Access Compliance Report

Public Rights-of-Way

(Curb Ramps)

Intersection ID: 11262	Main Street: EASTWAY_DR	Cross Street: FRONTENAC_SHAMROCK_DR	Location: NW
ADA ID: 61C013C34DA6	Ramp Type: MedianPerp	Initial Pass/Fail: Fail	Overall Compliance: No
Severity Score: 12.5			
Codes/Mitigation Info/Possible Solution		Field Measurements/Component Compliance

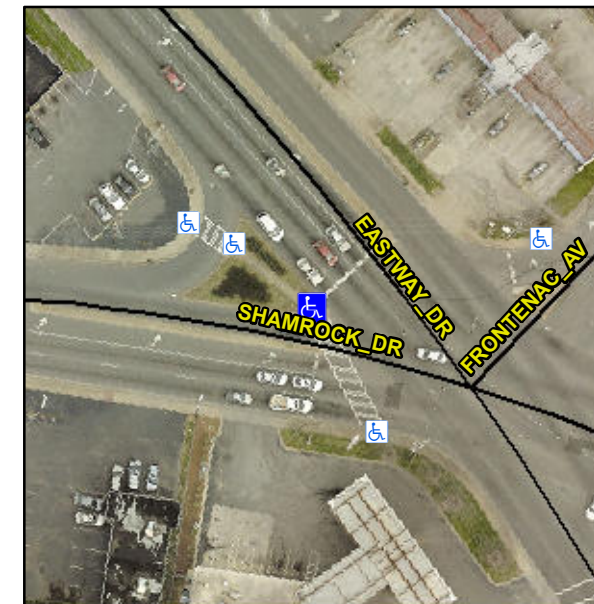
Not Found, R304.2.2

Compliance	Description	Data	Compliance	Description	Data
N/A	Ramp Length (in)	40.0	No	Ramp Slope (%)	9.0
Yes	Ramp Width (in)	48.0	Yes	Ramp XSlope (%)	1.9
N/A	Flare Type LT	N/A	N/A	Flare Type RT	N/A
N/A	Flare Slope LT (%)	N/A	N/A	Flare Slope RT (%)	N/A
N/A	Flare Traversable LT?	N/A	N/A	Flare Traversable RT?	N/A
N/A	Landing Length (in)	N/A	N/A	DWS Provided?	N/A
N/A	Landing Width (in)	N/A	N/A	DWS Contrast?	N/A
N/A	Landing Slope (%)	N/A	N/A	DWS Length (in)	N/A
N/A	Landing X Slope (%)	N/A	N/A	DWS Full Width?	N/A
N/A	Landing Curb? (Y/N)	N/A	N/A	DWS Offset (in)	N/A
N/A	Shared Landing?	N/A			
N/A	Gutter Ponding?	N/A	N/A	Gutter Slope (%)	N/A
N/A	Gutter Lip Ht (in)	N/A	N/A	Gutter X Slope (%)	N/A
N/A	Painted X Walk1?	Yes	N/A	Painted X Walk2?	N/A
	X Walk 1 Direction	To S		X Walk 2 Direction	N/A
N/A	X Walk 1 Width (in)	111.0	N/A	X Walk 2 Width (in)	N/A
	X Walk 1 Slope (%)	1.2		X Walk 2 Slope (%)	N/A
	X Walk 1 X Slope (%)	0.7		X Walk 2 X Slope (%)	N/A

Remove & Replace Entire Ramp.
